PRODUCT SAFETY BULLETIN

CSB400 Series

June 10, 2013

To: CUSTOMERS WHO PURCHASED FISHER® CSB400 SERIES REGULATORS.

Figure 1: Balanced Port and Stem Assemblies

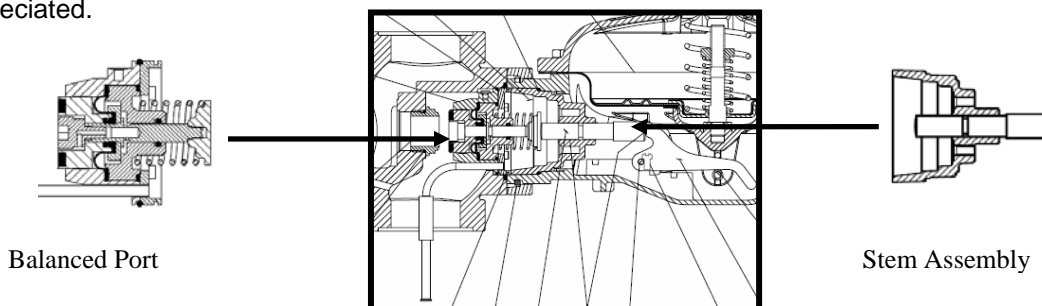
Regulator Technologies Inc. has received a small number of field returns of the Fisher CSB400 Series regulators which allowed the outlet pressure to drop below acceptable levels when flow rates increased. After evaluating these few returns it was found that the balanced port and stem assembly shown in Figure 1 were not manufactured with the proper amount of lubrication. Regulators with this condition may allow the outlet pressure to drop below or rise above the regulators accuracy with flow rate changes.

For the CSB400 Series regulator installed without an external overpressure protection device or installed as a monitor providing overpressure protection, these installations may allow the outlet pressure to increase above the regulator set point and reach full inlet pressure potentially leading to a downstream system leak, equipment damage, and explosion or fire. These installations need to have the balanced port and stem assembly changed out as soon as possible.

For the CSB400 regulators installed with an external overpressure protection device, this condition may cause the outlet pressure to rise into the setting of the external overpressure protection device causing this device to activate.

To ensure the regulator will operate properly, the balanced port assembly and the stem assembly shown in Figure 1 need to be replaced with new parts at the next scheduled maintenance interval.

1. Locate all CSB400 Series regulators.
2. Contact your local Emerson LBP to order the required repair parts kit.
3. Schedule maintenance to change the balanced port and stem assemblies.
